Our Case Number: ABP-314056-22

Re: Liffey Valley to City Centre Core Bus Corridor Scheme.
Fonthill Road to High Street all in the County of Dublin.

Liffey Valley to City Center Core Bus Corridor (Case: 314056)

Extract of Landscape Arrangements Sheet 20

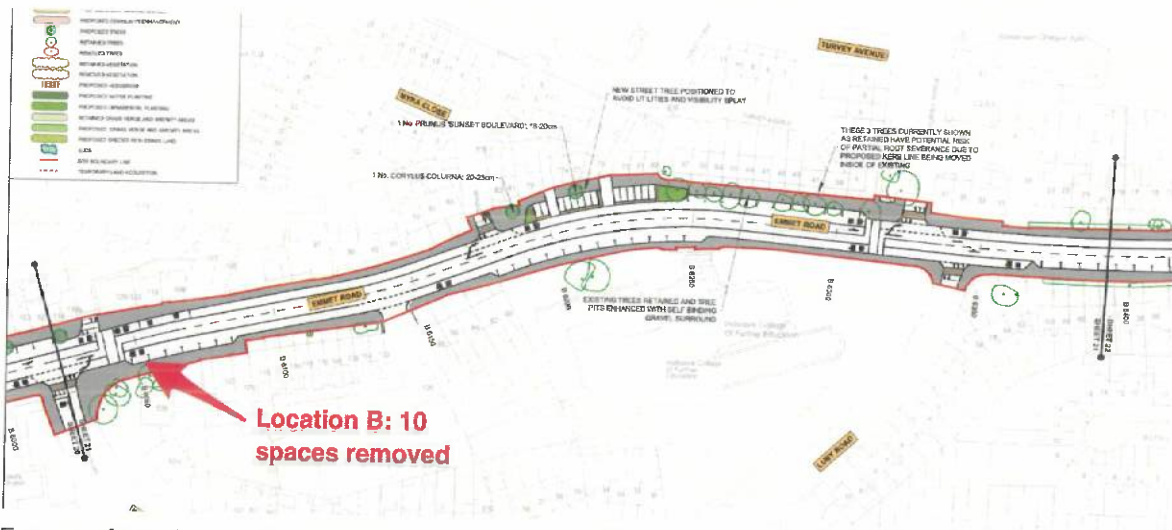
The Landscape Arrangements do not show additional bike parking along Emmet Road. In combination with what is stated in EIAR Chapter 6 page 35 cycle parking is being removed from Emmet Road. In fact it shows 28 cycle parking spots being removed without alternatives.

Existing cycle parking outside 139 Emmet Road / St Pat's Stadium that will be removed

Our request for cycle parking to be retained on Emmet Road by converting 2 or 3 of the proposed 93 car parking spots (EIAR Chapter 6 pg 78) is not unreasonable.

Extract of Landscape Arrangements Sheet 21

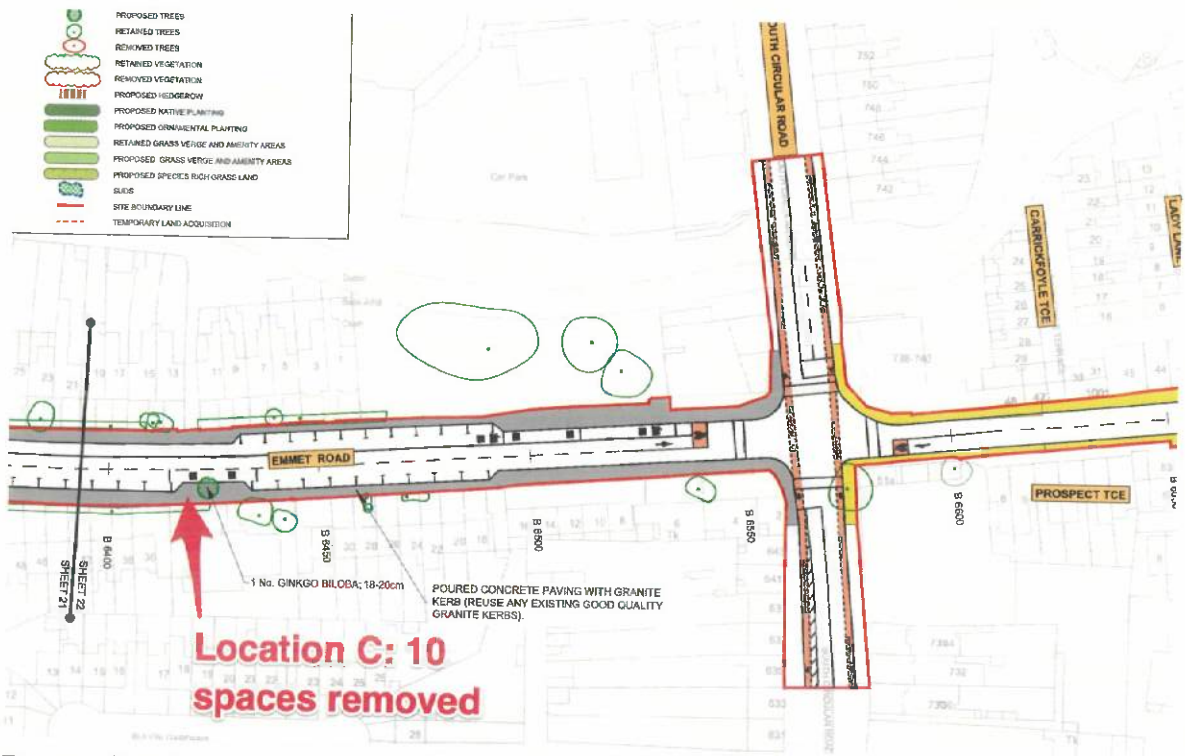
Existing cycle parking outside 122 Emmet Road that will be removed

TYPICAL CROSS SECTION O-O
BALLYFERMOT ROAD

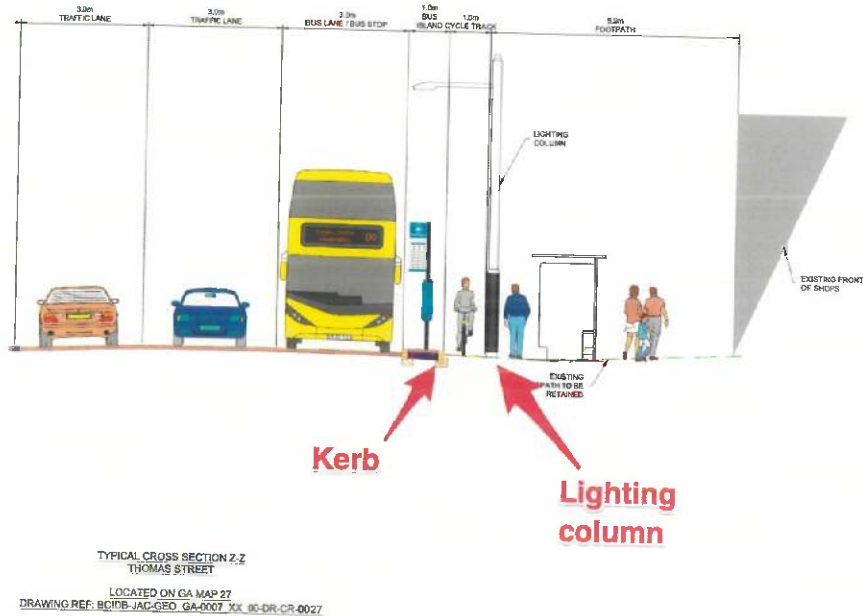
Again the NTA response misleads. While we acknowledge that the desired width isn't always possible, there are locations where the cycle track is well below 1.5m and with kerbs/lighting columns at the cycle track edge further constraining the effective width. Below are two examples of 1m cycle tracks that are constrained on both sides.

These narrow cycle tracks of 1m with vertical constraints on either side will be inaccessible to some types of cycles. Many cargo bikes are 70cm wide and tricycle cargo bikes are 85cm wide. This includes cargo bikes that are part of the Dublin City Council / Bleeper Bike cargo bike trial.

These tricycle cargo bikes have a wheel width of 85cm. The National Cycle Manual states a “wobble room” of 250mm (section 1.5) to account for the kinetic envelope of the cycle. Guidance for disabled cyclists charity Wheels for Wellbeing states a minimum cycle track width of 1.5m¹. The UK’s cycle design manual states an absolute minimum width of 1.5m with more needed when there are adjacent vertical elements like street poles.²

In Cross-Section Z-Z above the cycle track is 1m beside a 5.9m footpath. A small narrowing of the footpath would ensure the cycle track would accommodate all types of cycles. Otherwise there is a high likelihood of disabled cyclists or cargo bike users getting stuck in a narrow cycle track.

- With the aim of encouraging more cycling to local amenities replace two or three of the 92 car parking spots on Emmet Road to replace the 28 cycle parking spots that are being removed without replacement
- To ensure that disabled cyclists are not discriminated against and to support the growth of cargo bikes for parents carrying kids and business moving cargo. Ensure a minimum cycle track width of 1.5m when there is a kerb or lighting pole adjacent to the cycle track. Otherwise ensure there is the potential for wide cycles to overrun the footpath area by removing any kerbs
